Title of Change:	The change is to improve product package robustness by changing of ICD2PAK 5LD from dual gauge to single gauge frame, add in mold lock on the heatsink and change mold compound from G600 to G700HF.
Proposed First Ship date:	01 Dec 2022 or earlier if approved by customer
Contact Information:	Contact your local onsemi Sales Office or AhmadFaris.Dzulkipli@onsemi.com
PCN Samples Contact:	Contact your local onsemi Sales Office. Sample requests are to be submitted no later than 30 days from the date of first notification, Initial PCN or Final PCN, for this change. Samples delivery timing will be subject to request date, sample quantity and special customer packing/label requirements.
Additional Reliability Data:	Contact your local onsemi Sales Office or AbdulRasyid.Ruslan@onsemi.com
Type of Notification:	This is a Final Product/Process Change Notification (FPCN) sent to customers. FPCNs are issued 90 days prior to implementation of the change. onsemi will consider this change accepted, unless an inquiry is made in writing within 30 days of delivery of this notice. To do so, contact PCN.Support@onsemi.com

Final Product/Process Change Notification

Document #: FPCN23071XB

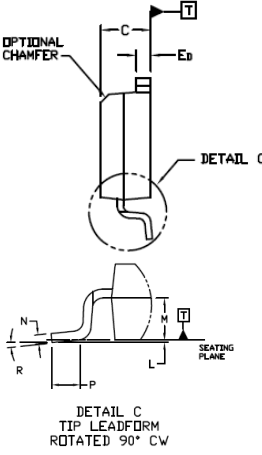
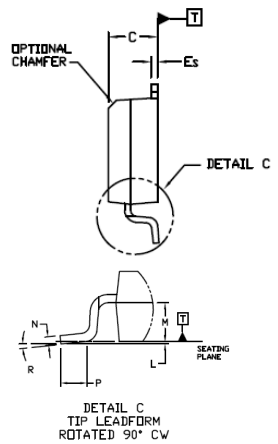
To notify customers of the change in leadframe supplier from KOBE to SDI, heatsink thickness from 50mils to 20mils, add in mold lock design on heatsink and change mold compound from G600 to G700HF. The change is to improve product package robustness.

Item	Before Change Description	After Change Description
LeadFrame	Heatsink thickness: Dual Gauges (50mils) Heatsink area: No mold lock	Heatsink thickness: Single Gauge (20mils) Heatsink area: add in mold lock
Mold Compound	G600	G700HF
Package case outline	 <p style="text-align: center;">CASE 936A-02 Issue D</p> <p>Heatsink Thickness E_D: 1.143-1.397mm Package thickness (C): 4.318-4.572mm</p>	 <p style="text-align: center;">CASE 936A-02 Issue E</p> <p>Heatsink Thickness E_S: 0.457-0.660mm Package thickness (C): 4.318-4.572mm *Detail C and all the other dimension remain same.</p>
